AGENDA ITEM SUMMARY / STAFF REPORT**ITEM NO: 4****FLORENCE PLANNING COMMISSION**Meeting Date: January 9, 2024

ITEM TITLE: PC 23 25 PUD 01 – Myrtle Glen – 37th and Oak Final PUD Application

**FINDINGS OF FACT
FLORENCE PLANNING COMMISSION
EXHIBIT "A"**

Meeting Date: January 9, 2023 **Planner:** Clare Kurth & Wendy FarleyCampbell
Application: PC 23 25 PUD 01: Myrtle Glen PUD

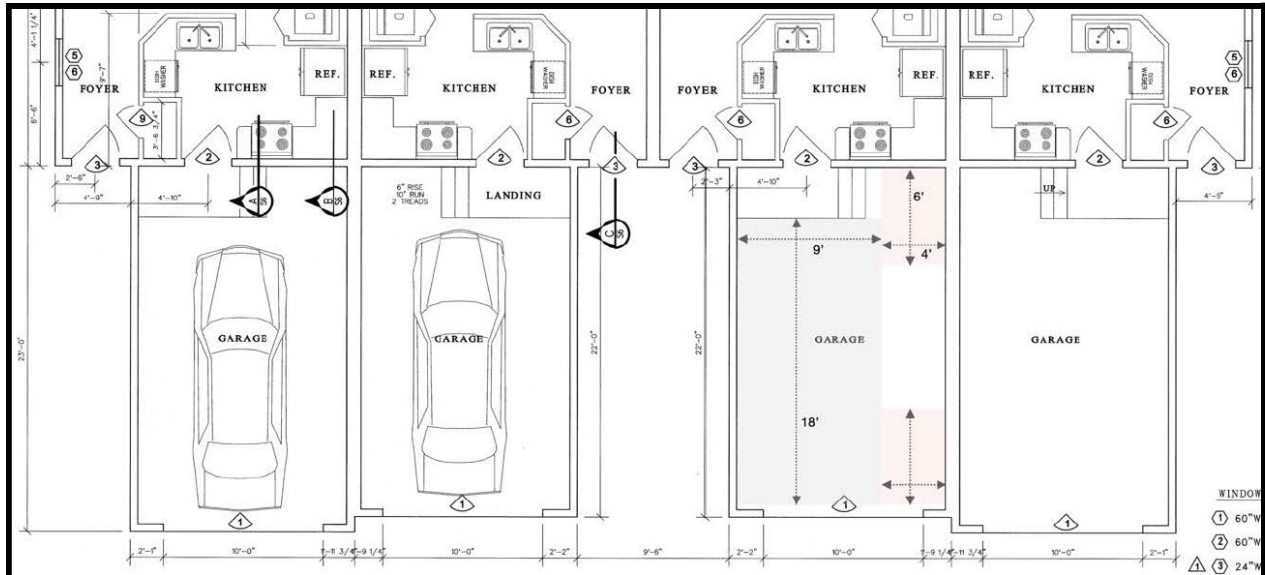
6.4 The applicant shall either provide long term bike parking that meets criteria in accordance with FCC 10-3-10-C or the applicant shall provide other long term bicycle parking onsite in accordance with FCC 10-3-10, this required long-term bicycle parking may either be located on individual sites or in common space. Long term bike parking will be verified prior to Certificate of Occupancy of each unit if provided on the individual lots, or with final PUD if provided in common or open space.

The applicant has provided sufficient evidence that there is adequate space within the interior of the garage to accommodate the parking of a standard sized car and the minimum clearance distance of 4 feet from the wall to the vehicle in accordance with FCC 10-3-10-C and this Condition. Please see the dimensioned image below from page 2 of Exhibit G. It further illustrates the available area from the 4-unit garage dimensions provided on Sheet S2 of Exhibit D-Attachment 2. The 3-unit garage dimensions are provided on Sheet S2 of Exhibit H-Attachment 5 and are a few inches narrower but meet the intent. This Condition is satisfied.

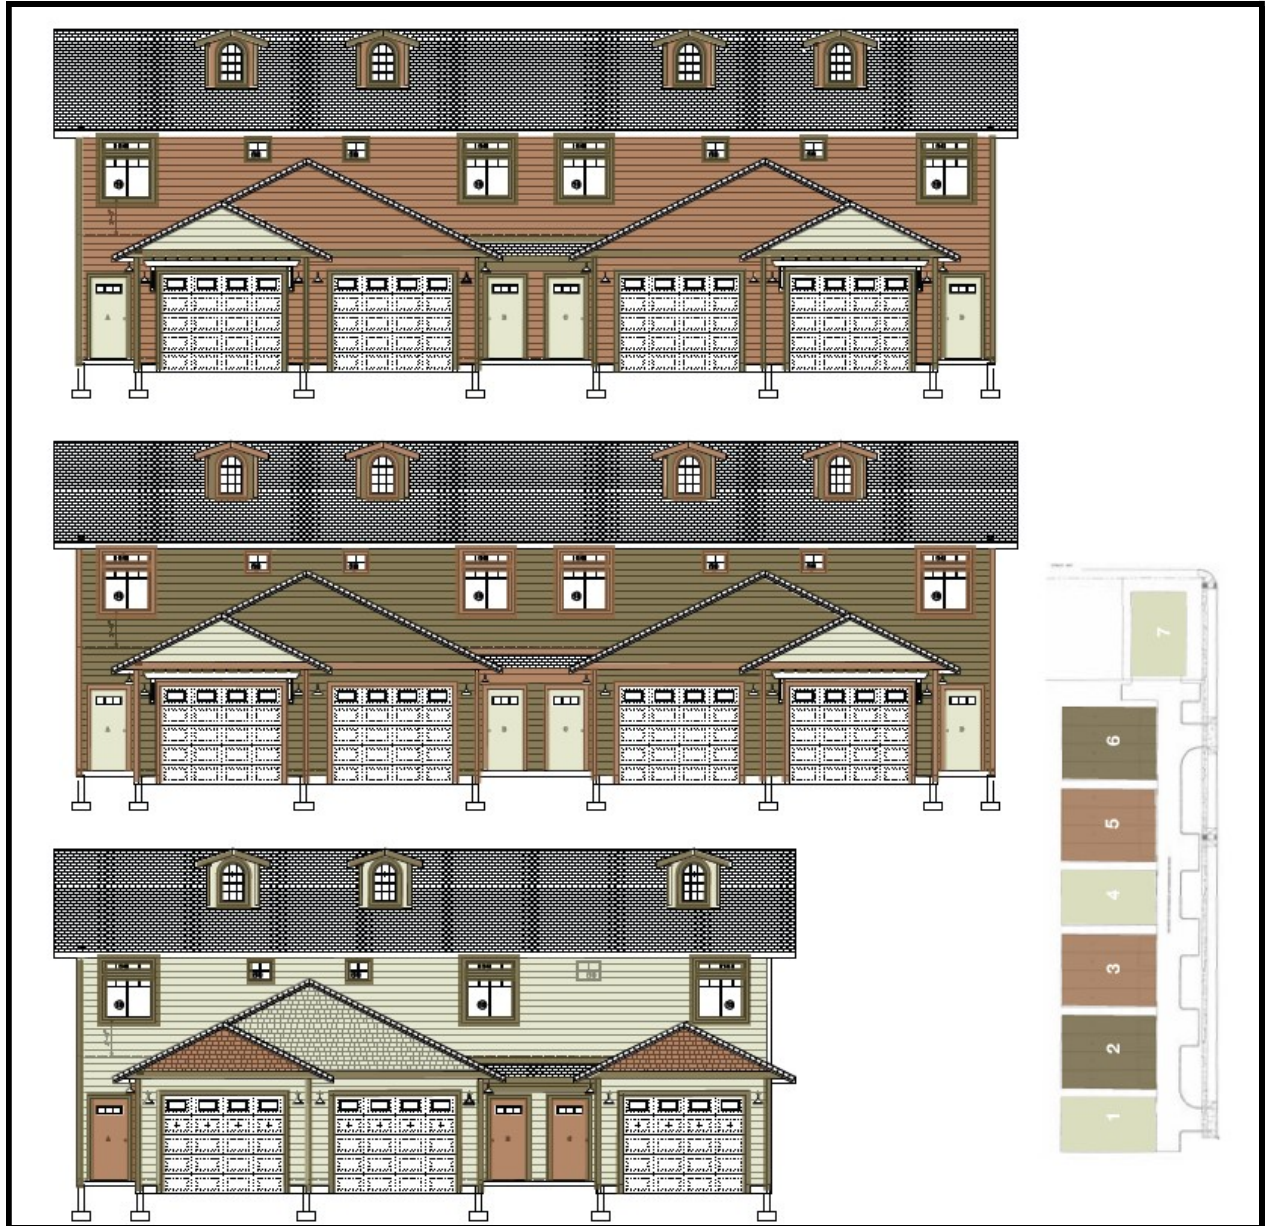
The proposed building designs include three color arrangements from a pallet of three colors- green, brown and tan. The three sets of three-unit buildings are proposed to have a base of tan paint while the four four-unit buildings are proposed to have green and brown bases (2 each). Each of the three-color arrangements alternate as seen in Attachment 6 (below) (Exhibit I).

Façade changes are proposed as a variation in gable siding on the four-unit buildings (horizontal lap siding) and the three-unit buildings (shingle pattern siding). The shingle pattern siding shall be used on the four-unit building garage gables rather than the three-unit buildings to better break up the proposed long uninterrupted expanse (two sets of 150 ft.) of the same building style using horizontal lap siding (**Condition 7.2**). Please see the image below from Attachment 6:

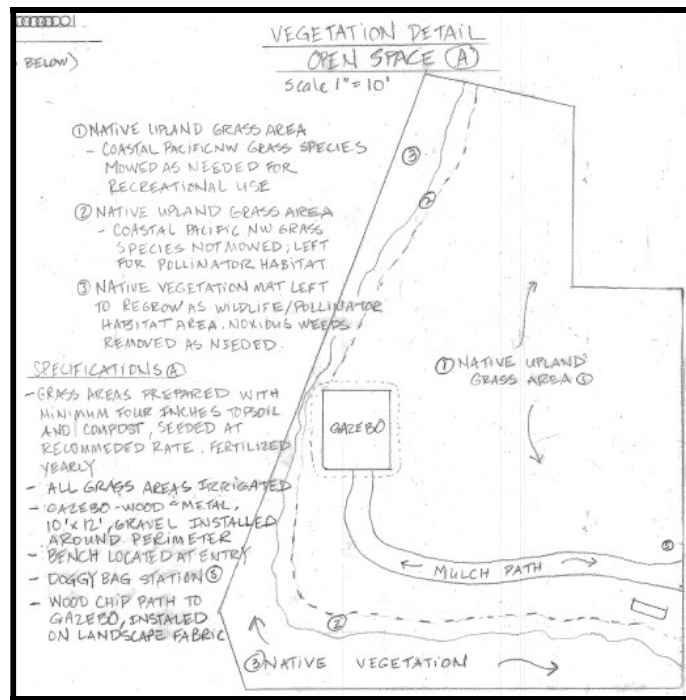
7.7 A tentative concept plan with development amenities for the park area supporting both active and passive recreation shall be submitted with final PUD. Prior to issuance of the building permits for the fifth cluster of units the applicant shall submit and have approved a Final PUD approval for the proposed recreation area that is contained within the existing tax lots associated with this project.

Attachment 3, Sheet L1 (Exhibit E) includes details of Open Space A and Open Space B that are proposed to meet the recreation open space requirement for this project. Both of these recreational open space areas are entirely contained within the tax lots associated with this project. This component of the Condition has been satisfied.

FCC 10-36-6: Easements states that no building, structure, tree, shrubbery, or other obstruction shall be placed or located on or in a public utility easement. In accordance with this code section the proposed gazebo / shelter shall not be placed within the 20-foot PUE and planting of trees within the easements on this site (Condition 10). In accordance with Public Work Director's comments (Exhibit R), any trees planted in Recreational Open Space Area B shall be planted a minimum of 7.5 feet from the actual stormwater pipe and shall be planted with a root barrier to minimize risk of root damage to the stormwater facility (Condition 18). The proposed benches, pet waste station, and walking path may only be installed within the easement with written approval of the City of Florence Public Works Director. All potential obstructions are encouraged to be installed outside of an existing or proposed easement.

Sufficient evidence has not been submitted in the tentative concept plan that the recreation open space is supporting both active and passive recreation. Below are snips of the two open space areas proposed. Additional information was submitted December 28th regarding open space tentative concept plans.

10. In accordance with FCC 10-36-6 no building structure, tree, shrubbery or other obstruction shall be placed or located on or in a public utility easement. The proposed gazebo / shelter and trees shall not be planted or install within and existing or proposed easement on site. The proposed pet waste stations, benches, and walking paths shall only be installed in an existing or proposed easement with written approval from the City of Florence Public Works Director.

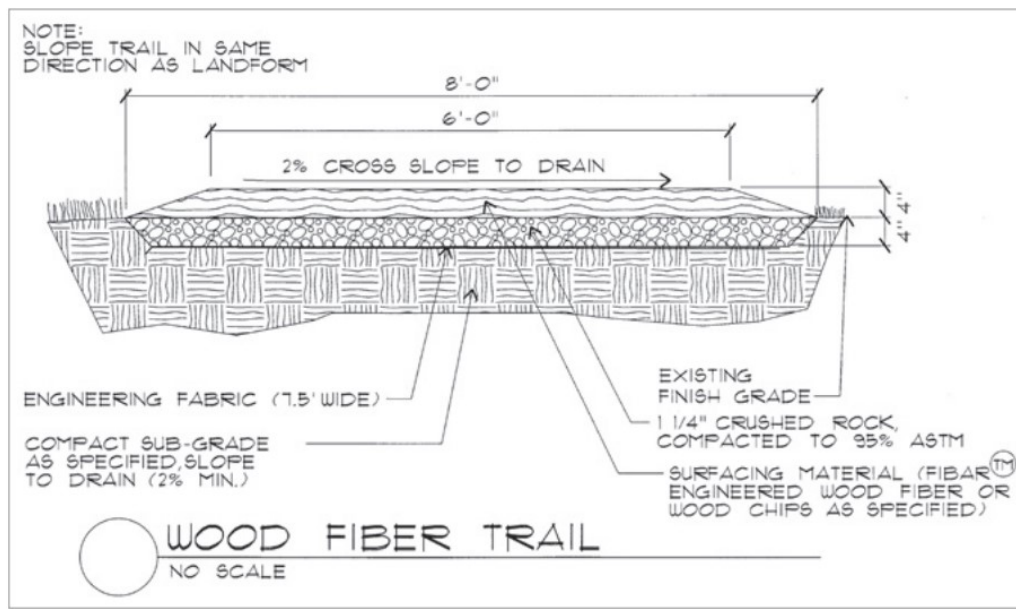
The proposed walking path is stated to be 'wood chips on landscape fabric.' In consistency with the *Portland Parks & Recreation Trail Design Guidelines for Portland's Park System* wood fiber trail typical included below the path shall include engineering fabric a minimum of 7.5 feet in width, 1.25" crushed rock compacted to 95% ASTM a minimum of 4" in depth, and engineered wood fiber or chips a minimum of 4" in depth. The proposed path shall have a minimum 2% cross slope to ensure adequate drainage of the pathway and at no point shall include longitudinal slopes above 8%.

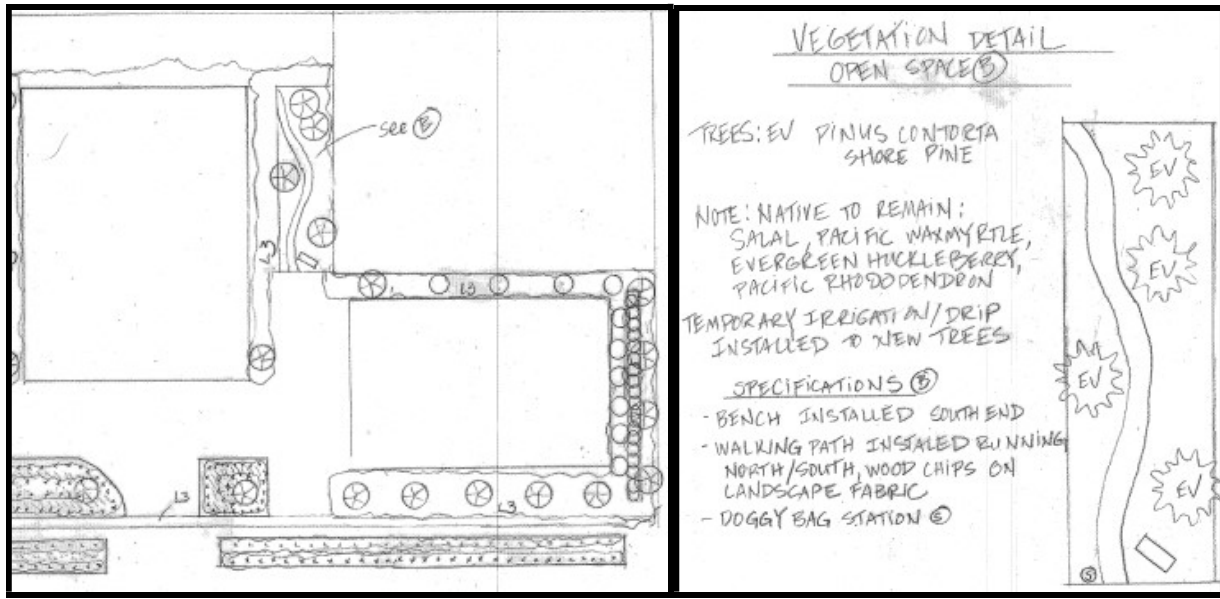
Exhibit R, the Public Works Director states that the proposed benches appear light duty and not appropriate for use in the common areas. Additional details shall be submitted to the City Community Development Department demonstrating that the proposed bench is of high quality and constructed of durable materials in consistency with City park standards (Condition 17). The pet waste station shall be installed using an aluminum post to increase life of the unit and decrease maintenance requirement associated with other materials such as wood (Condition 16).

13. In accordance with Public Works Director's Comments in Exhibit R, benches with high durability shall be installed. Revised bench specification shall be submitted for review and approval by the Community Development Department and Public Works. In addition, there shall be a minimum of 2 benches install under the gazebo of the same quality and similar dimension as approved through this condition and approved by the above mentioned City departments..

16. The proposed pet waste stations shall be installed on aluminum posts to extend their functional life, durability, and decrease maintenance requirements.
17. Additional details shall be submitted for the proposed benches prior to installation and be subject to final review by the Public Works Director to ensure compliance with high durability and quality of materials that meet the intent of the recreational area.
18. In accordance with Public Works Director's comments in Exhibit R, any and all trees planted in Recreational Open Space Area B shall be a minimum of 7.5 feet from the actual stormwater line and shall be planted with a root barrier to minimize risk of tree roots entering the stormwater pipe. A product such as Deep Root Tree Root Barrier shall be used for all tree planting in Recreational Open Space Area B

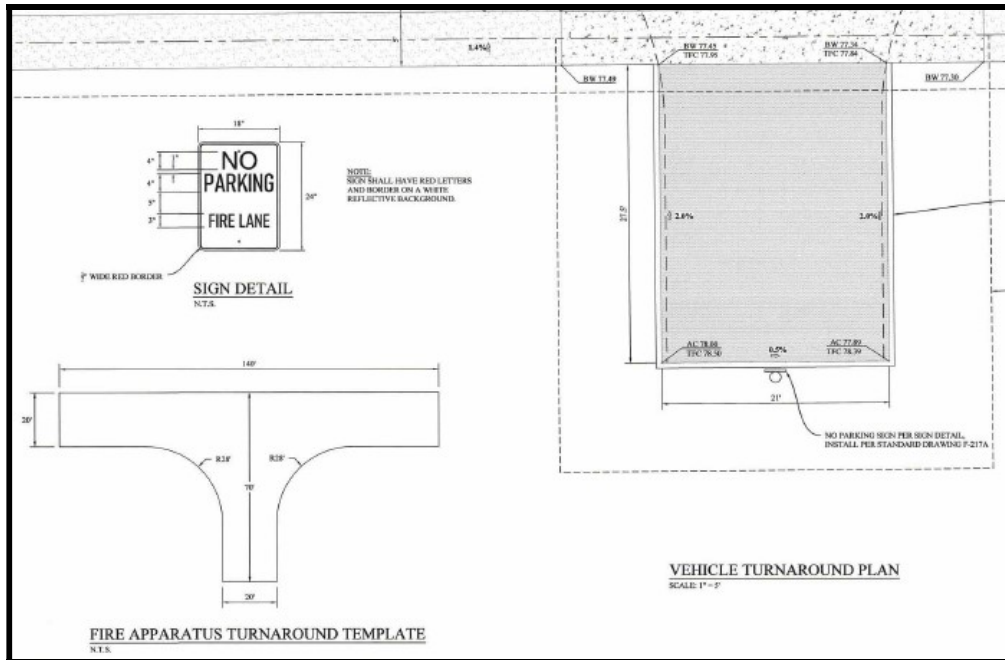
8.2 The maximum driveway width allowable under FCC 10-35-2-12-B for driveways serving single-family residences shall not be more than 24 feet shall be a minimum of 18 feet where the driveway provides two-way traffic. Therefore, the two driveway access points proposed on 37th St shall be a maximum of 24 feet in width and a minimum of 18 feet.

The driveway widths are included on Attachment 1, Sheet C9. These driveway widths are dimensioned at 24 feet in width each. This Condition has been satisfied.

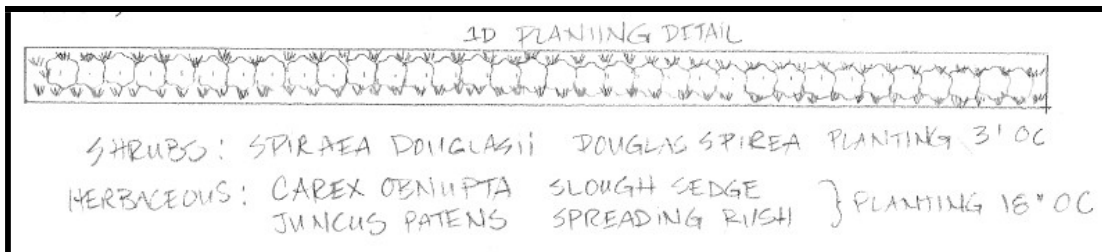
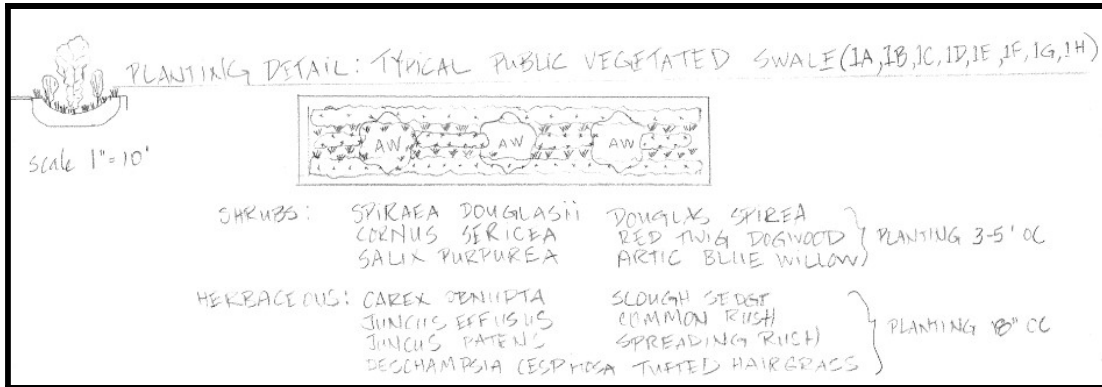
8.6 Vision clearance at 37th and Oak Street shall be confirmed during building inspection or by staff site visit prior to final approval to ensure compliance with minimum vision clearance.

Below are snips from Attachment 3, Sheet L1 from the landscaping plan (Exhibit E). The top image is of the vegetated swale on the north side of 37th Street at the 37th and Oak Street intersection and the bottom image is of the planting area on the south side of the 37th and Oak Street intersection. These proposed planting areas use plantings that are not anticipated to interfere with vision clearance. This shall be confirmed during final building inspection as stated in this Condition.

Exhibit M

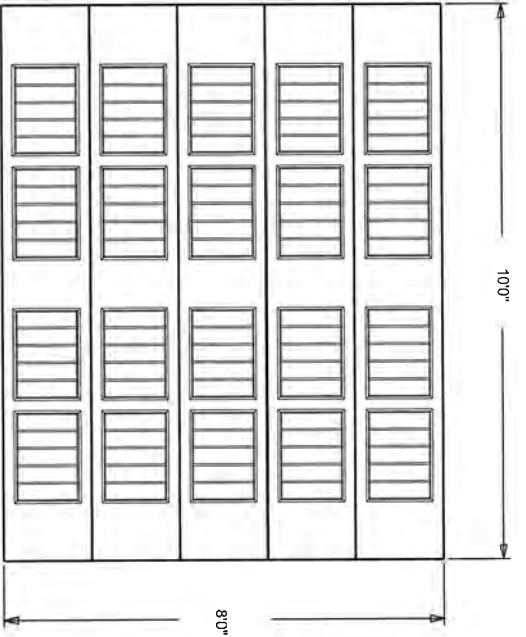
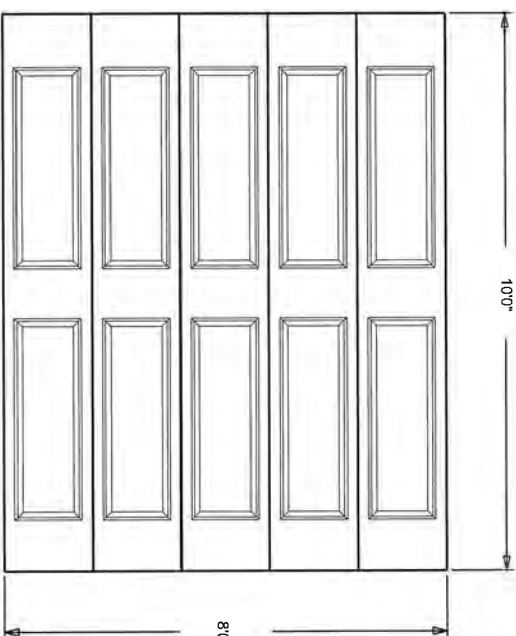
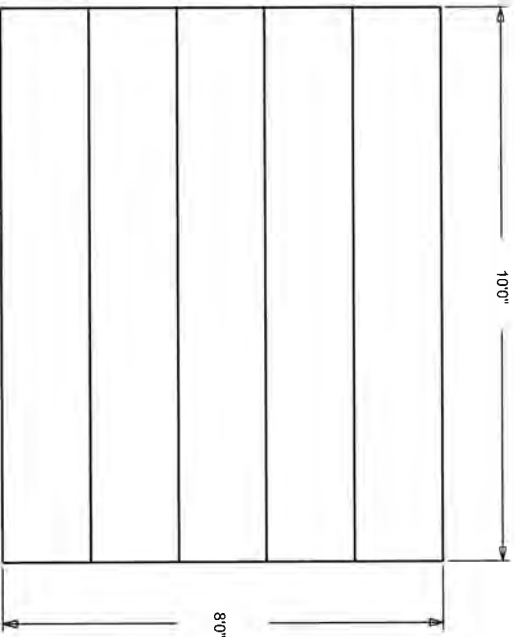
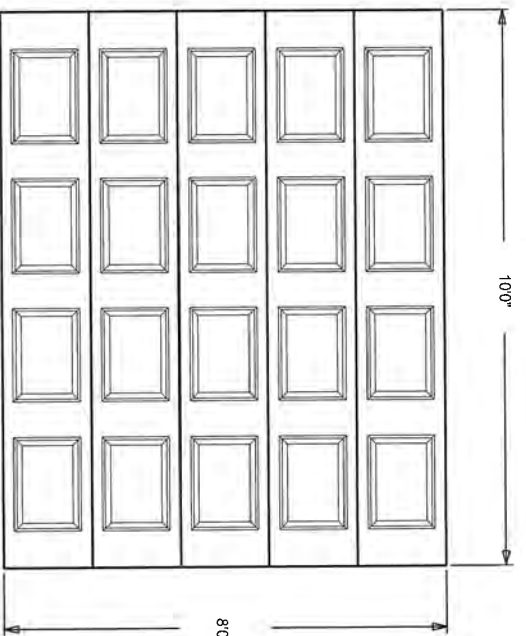
- Garage doors colors to be white as depicted on Attachment 6 Paint Colors Plan.
- Garage door type to vary/alternate between the types approximately depicted above.
- Buildings 1 and 5 will have the same garage door type; buildings 2 and 6 will have the same garage door type; buildings 3 and 7 will have the same garage door type; building 4 will have a unique garage door type

Front doors colors to vary as depicted Attachment 6 Paint Colors Plan.

- Buildings 1 and 5 will have the same front door type; buildings 2 and 6 will have the same front door type; buildings 3 and 7 will have the same front door type; building 4 will have a unique front door type

5. At the discretion of the Planning Commission, white garage doors are determined to be stark in comparison to the proposed color pallet. The garage doors on each unit shall be a color that is complimentary to the overall building color and one of the proposed colors submitted in Attachment 6, Exhibit I.
